3GPP TSG_CN#7
ETSI SMG3 Plenary Meeting #7,
Madrid, Spain
13th – 15th March 2000

NP-000091

Agenda item: 5.1.3
Source: TSG_N WG1
Title: CRs to 3G Work Item GPRS

This document contains “21” CRs on **Work Item GPRS**, that have been agreed by **TSG_N WG1**, and are forwarded to **TSG_N Plenary meeting #7** for approval.

Figure 10.5.127/TS 24.008: Receive N-PDU Number list information element

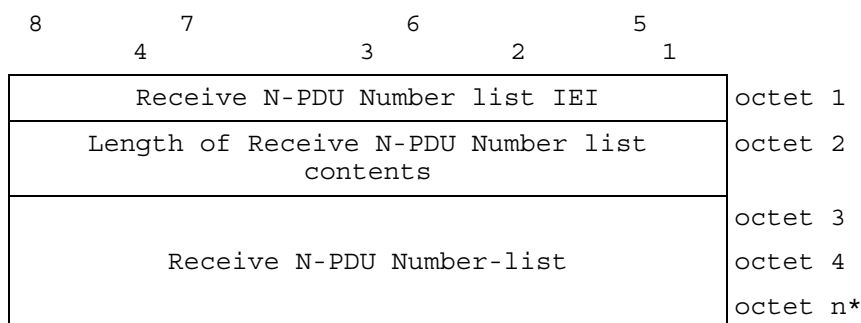
The *Receive N-PDU Number list* is a type 4 information element with a length of 4 to 19~~7~~ octets.

The value part of a *Receive N-PDU Number list* information element is coded as shown in figure 10.5.127/TS 24.008 and table 10.5.144/TS 24.008.

Figure 4.7.4/2 GSM 04.08: Network initiated GPRS detach procedure

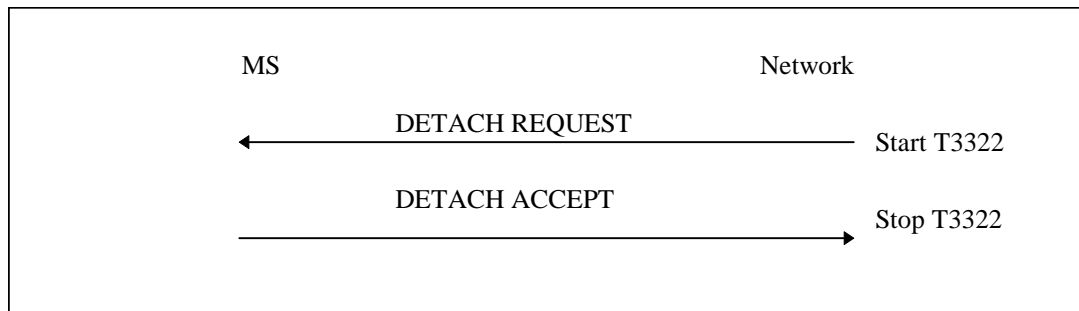
Reason for change: In the current version of 04.08 the network-initiated GPRS detach procedure results in the deactivation of all PDP contexts and release of all LLC links. The network-initiated GPRS detach procedure is however also used to indicate to the MS that it has become IMSI detached only, in which case it is still GPRS attached and fully capable to continue to use the activated PDP contexts. The PDP contexts should therefore not be deactivated in the IMSI detach case.

GPRS detach containing detach type "IMSI detach”:

If the network receives a ROUTING AREA UPDATE REQUEST message before the network initiated GPRS detach procedure has been completed, the network shall abort the detach procedure, shall stop T3322 and shall progress the routing area update procedure.

Figure 4.7.4/2 GSM 04.08: Network initiated GPRS detach procedure

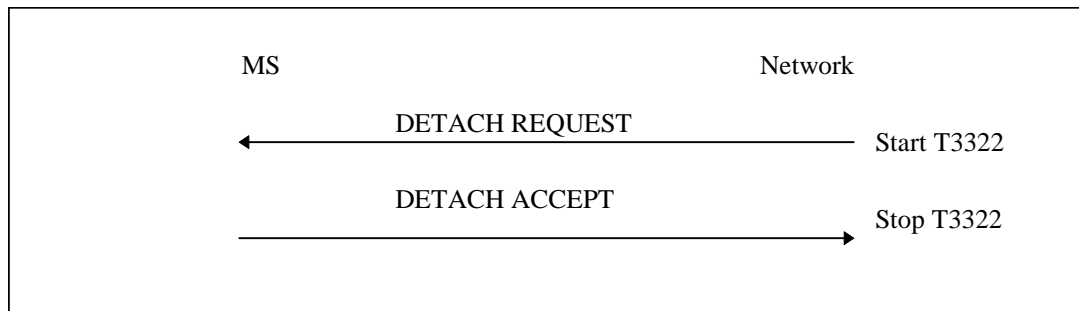
GPRS detach containing detach type "IMSI detach”:

If the network receives a ROUTING AREA UPDATE REQUEST message before the network initiated GPRS detach procedure has been completed, the network shall abort the detach procedure, shall stop T3322 and shall progress the routing area update procedure.

Figure 4.7.4/1 TS 24.008: MS initiated GPRS detach procedure

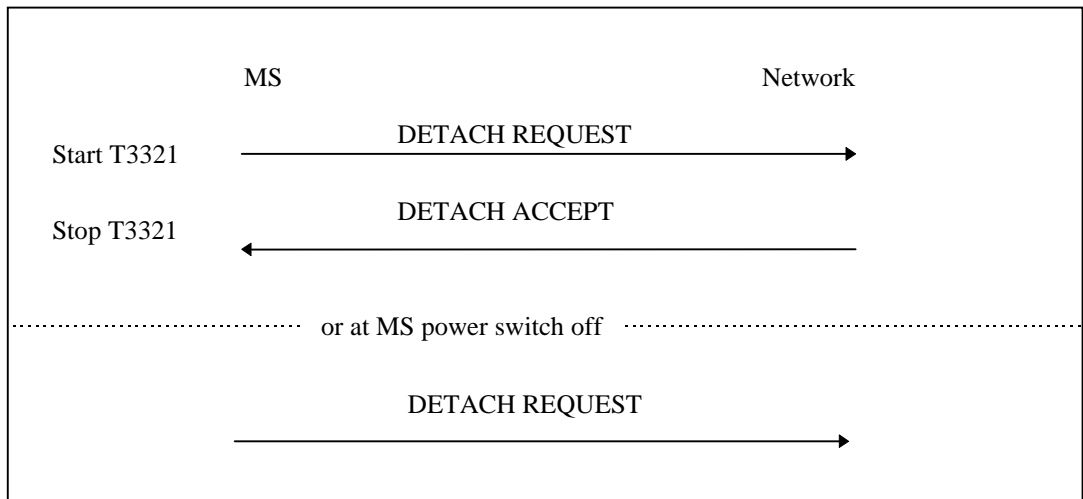
Reason for change: In the current definition of the MS initiated GPRS detach procedure, there is no time limit specified, when the MS may be deactivated even if the message is not yet transmitted. This CR proposes to define a maximum period of five seconds, until the MS may be switched off.

On the first expiry of the timer, the MS shall retransmit the DETACH REQUEST message and shall reset and restart timer T3321. This retransmission is repeated four times, i.e. on the fifth expiry of timer T3321, the GPRS detach procedure shall be aborted, the MS shall change to state:
